March 16, 2023

**RE: Golf Course & Westside Commercial Development  
Grading & Drainage Plans and Drainage Report  
Engineer's Stamp Date: 02/15/23  
Hydrology File: A12D008B2**

**RE: GOLF COURSE & WESTSIDE COMMERCIAL SUBDIVISION  
10850 GOLF COURSE R. NW  
GRADING PLAN AND DRAINAGE REPORT  
ENGINEER'S STAMP DATE: 11/16/22  
HYDROLOGY FILE: A12D008B2**

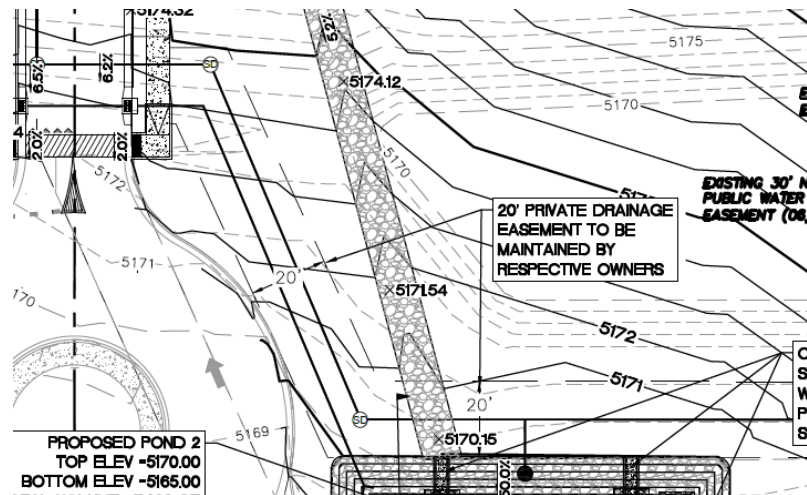
1. The overall drafting needs some serious attention. There are existing easements with labels that are too thick in pen width. These need to be shaded back.

2. There are proposed easements which just fade into the background. These need a little bit more pen width to them.

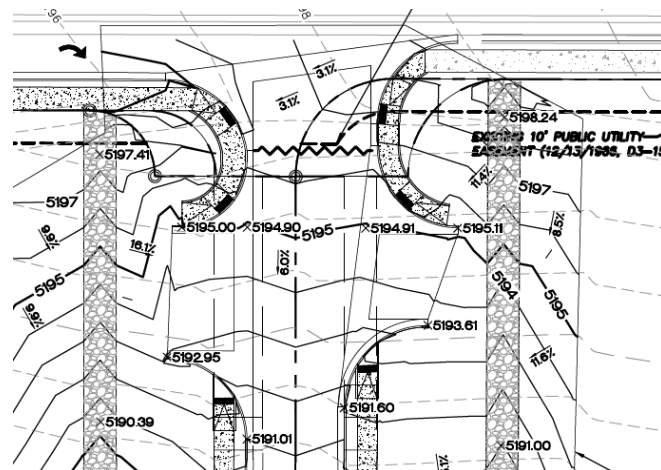
3. It appears that the entrances for Tracts D-1-A & D-1-B are too close to Westside Blvd. Please check with Transportation Section to verify the distance requirements.

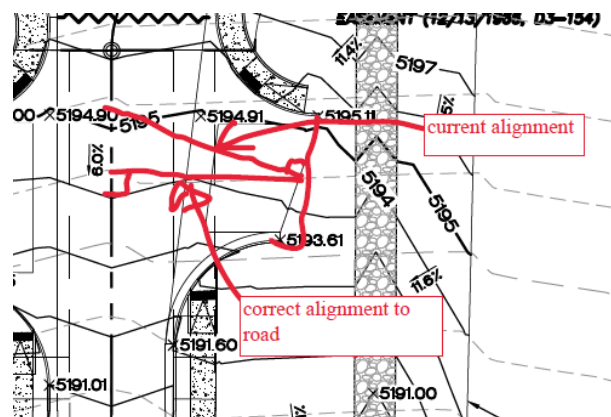
4. Please make all drives perpendicular to the private drives or public streets. There are several that are askew and need to be fixed.

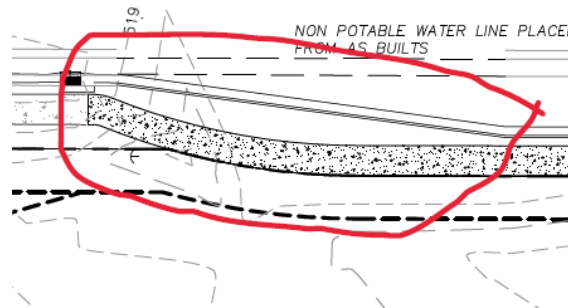
5. The proposed sidewalk in this area appears not to conform to construction conventions. Please verify with Transportation Section.

## Sheet C2

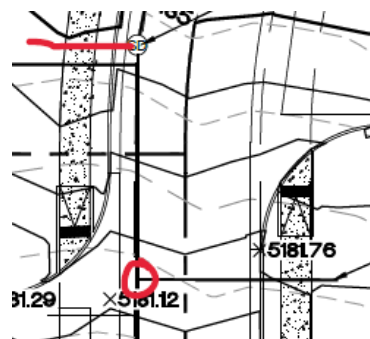
8. Depending on the material that is to be used, please fix the stub out connections. If RCP is to be used, then you will need manholes for the connections. If you use HDPE, then that is not needed since they do make Tee connections. If HDPE is to be used, please ensure that the tee connections are at least 5 feet from all manholes and inlets for buildability.

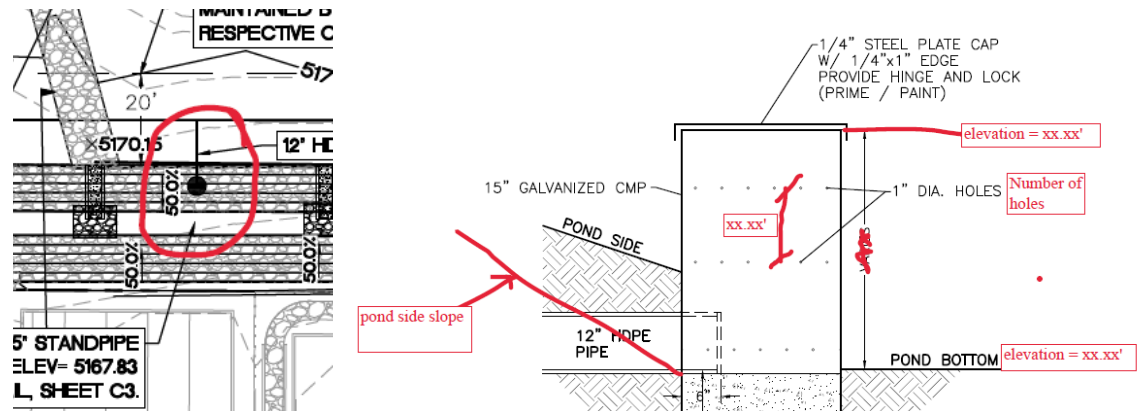
9. The proposed stand pipe will not function as shown. It needs to be at the bottom of the detention pond in order to work since the 1" dia holes will be drilled 360 degrees around the pipe. Also, the detail has information missing in order to build it as designed.

ENGINEER'S SEAL		DRAWN BY RG
	GOLF COURSE + WESTSIDE ALBUQUERQUE, NM		
	DATE 02/15/2022		2022055_GRB
	STORM DRAIN PLAN		
SHEET # <b>C2</b>			JOB # 2022055
TERRA WEST, LLC 5571 MIDWAY PARK PLACE NE ALBUQUERQUE, NM 87109 (505) 858-3100 www.tierrawestllc.com

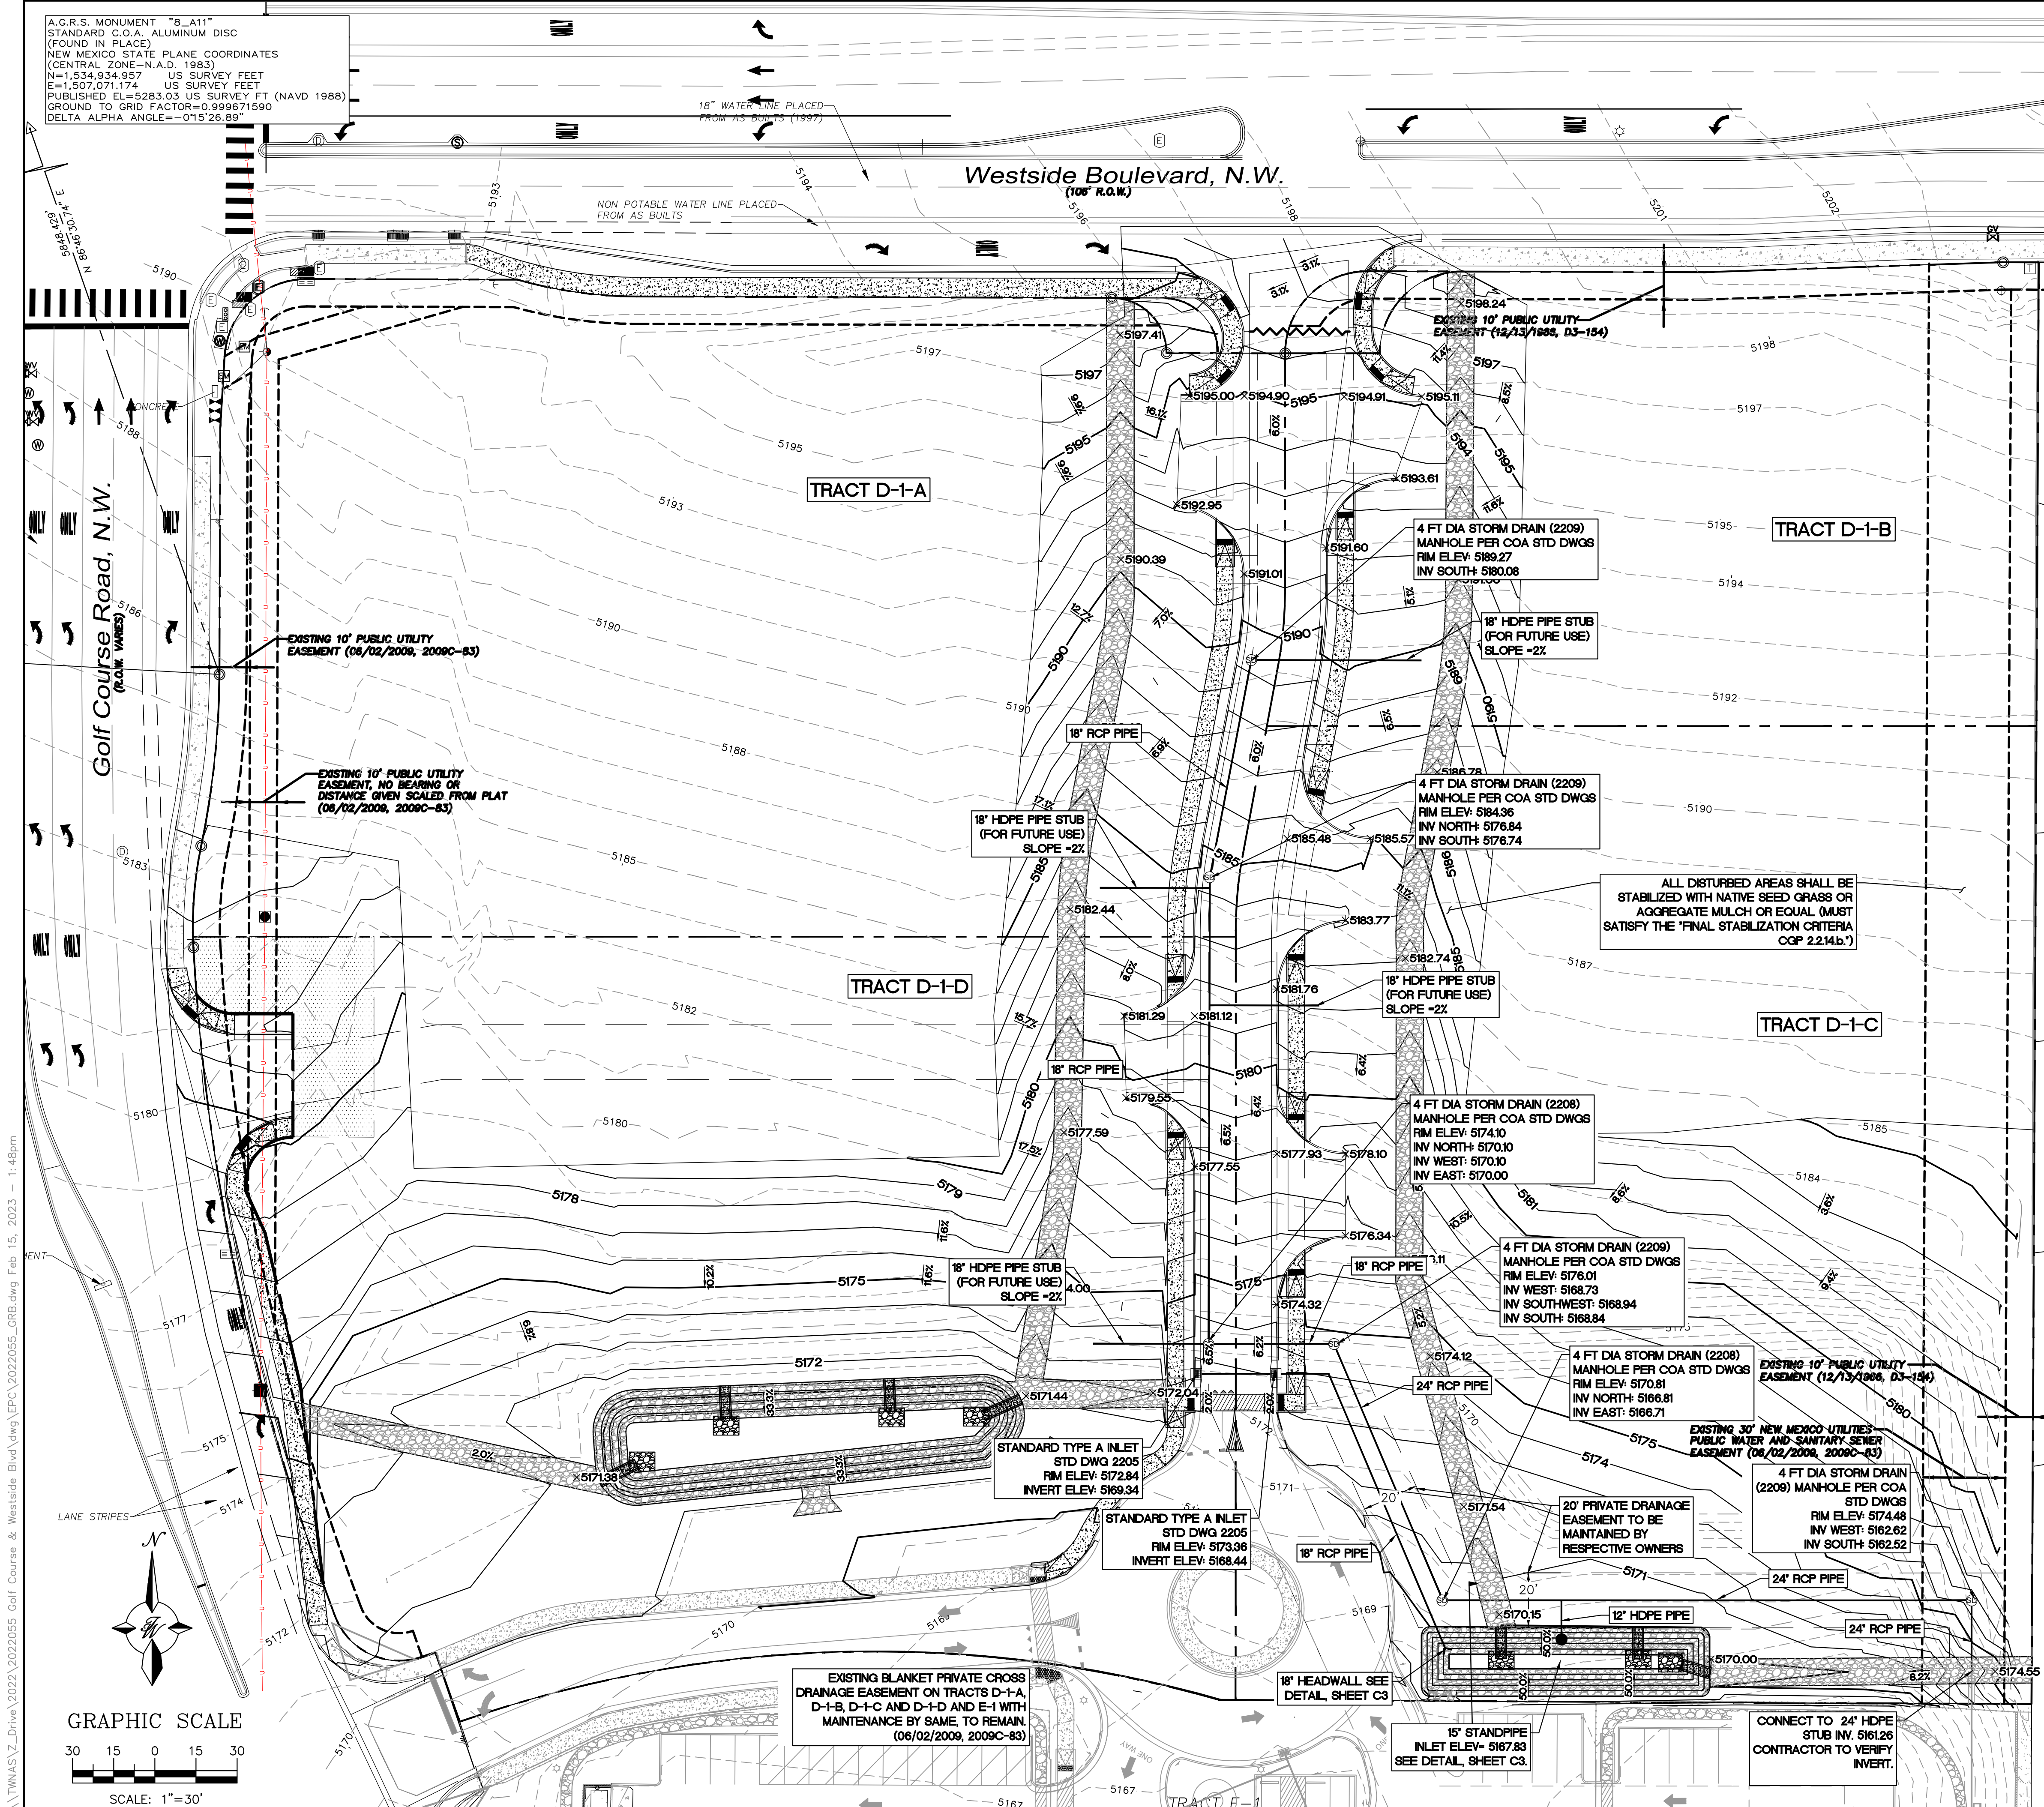
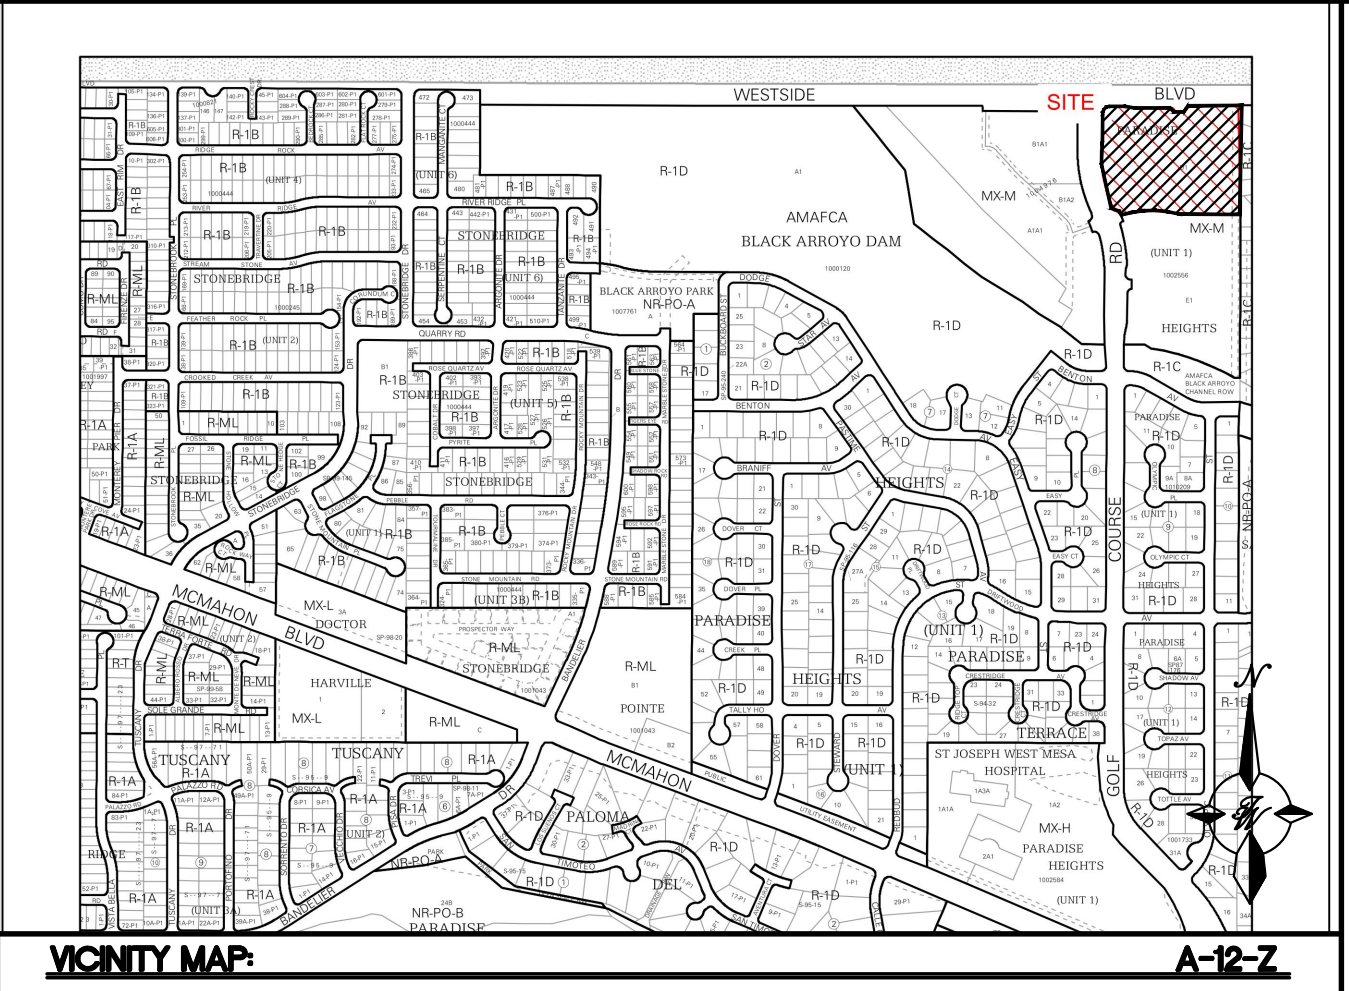
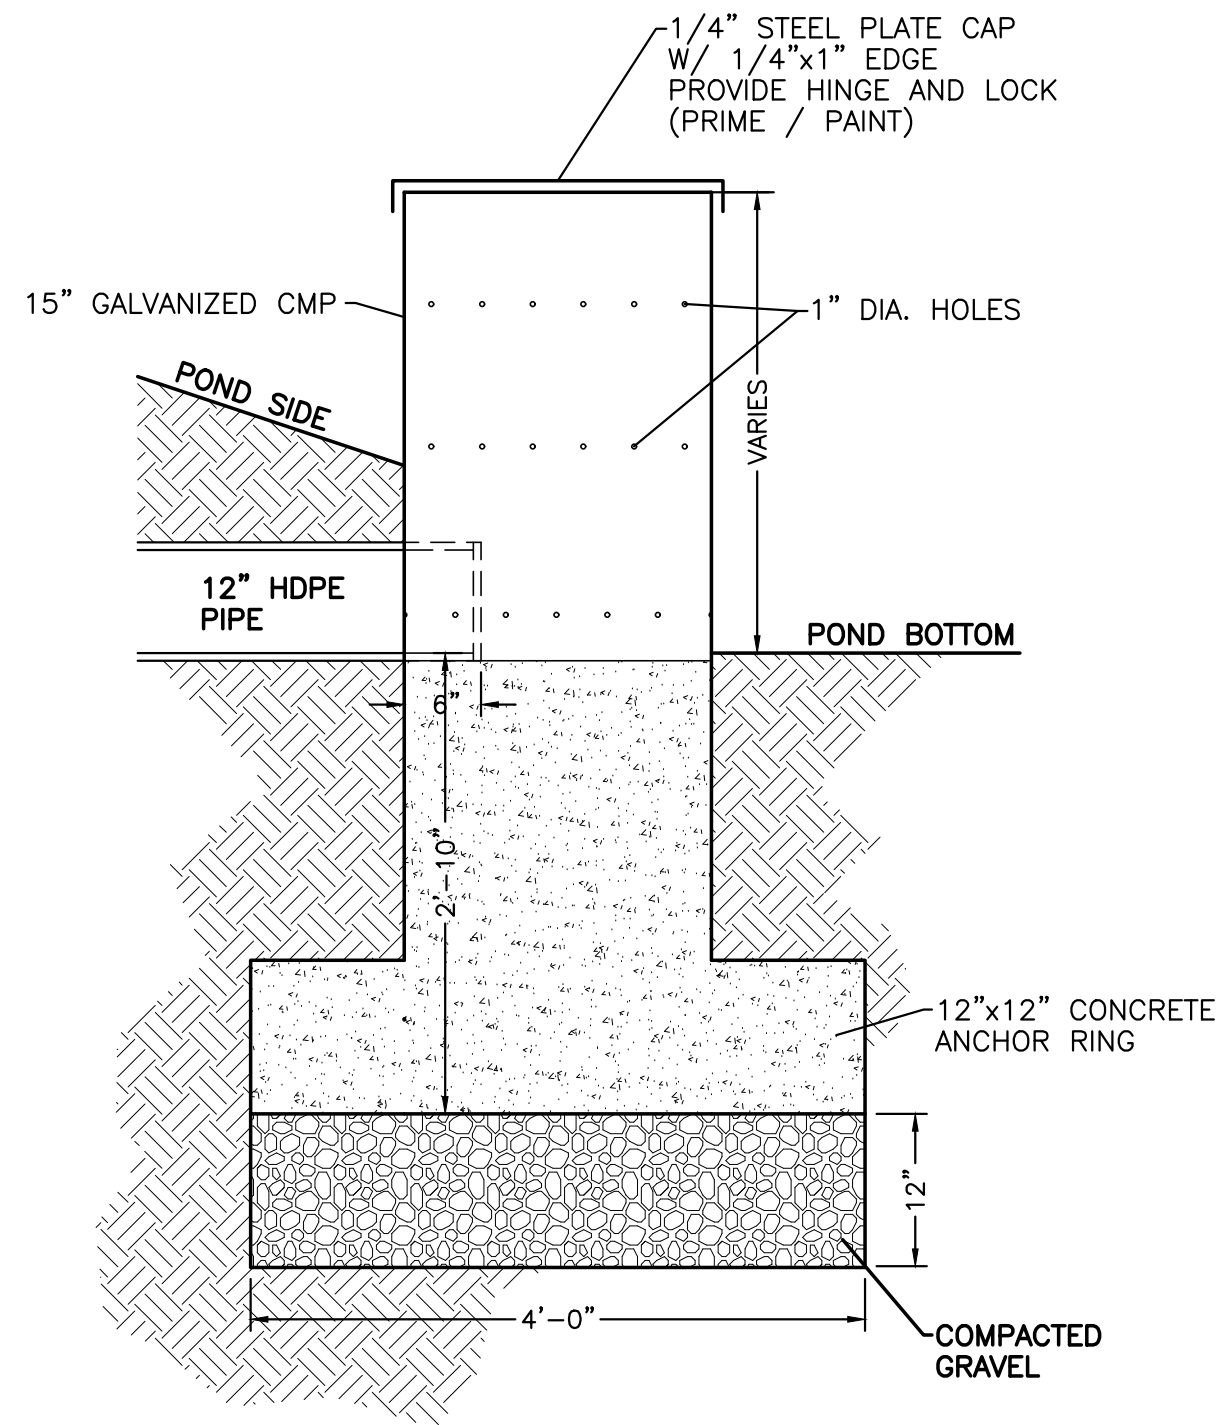
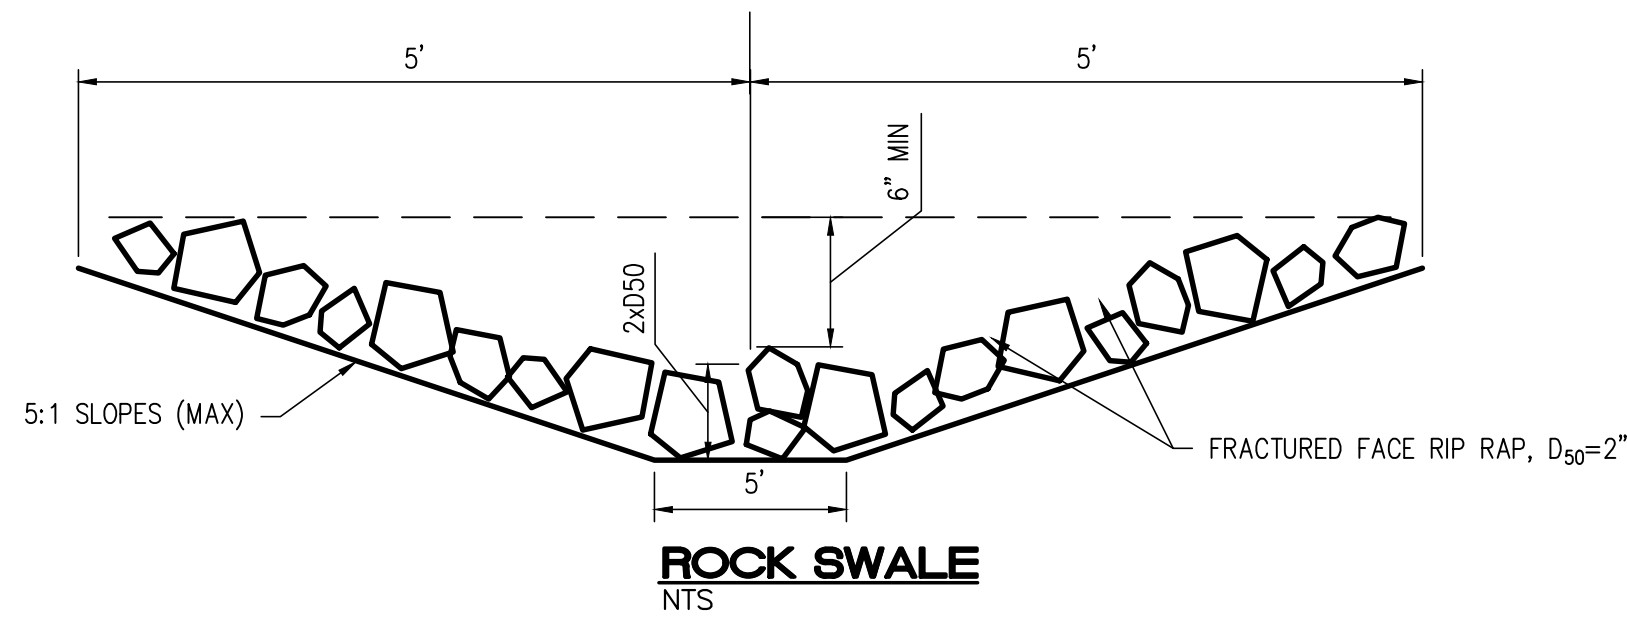
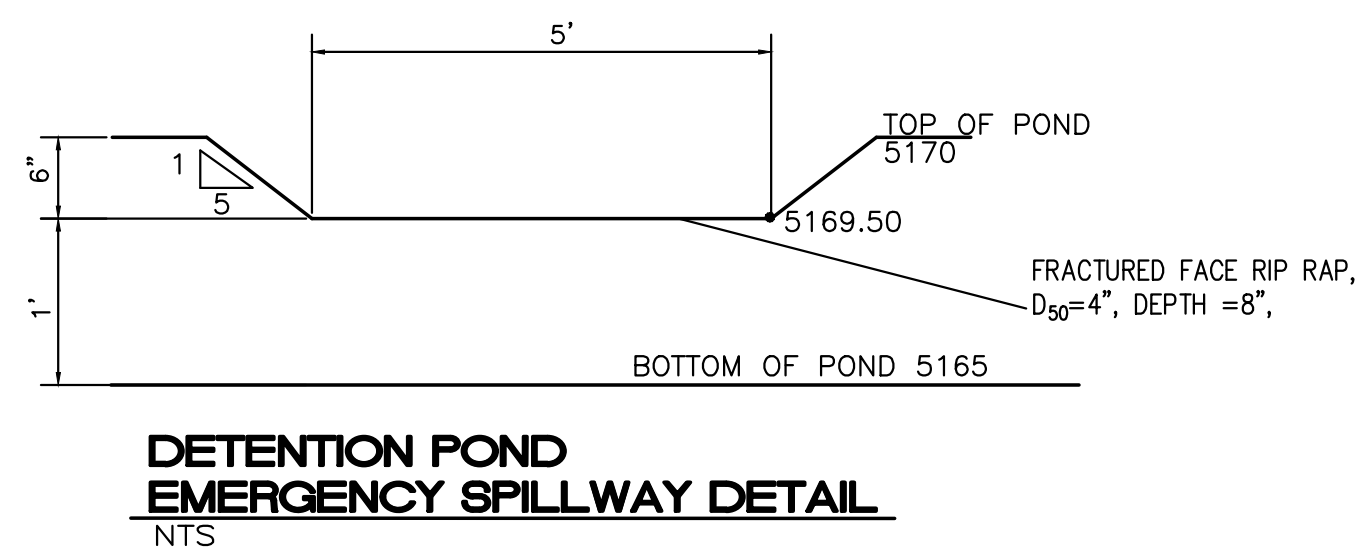
6. All the storm drain within the development is private. There are call outs for HDPE and then there are call outs for RCP. Since this is all private storm sewer, please stick with only one material type.

7. All stub outs should be only 5 feet beyond the proposed sidewalk and should have a plug with an inv elevation.
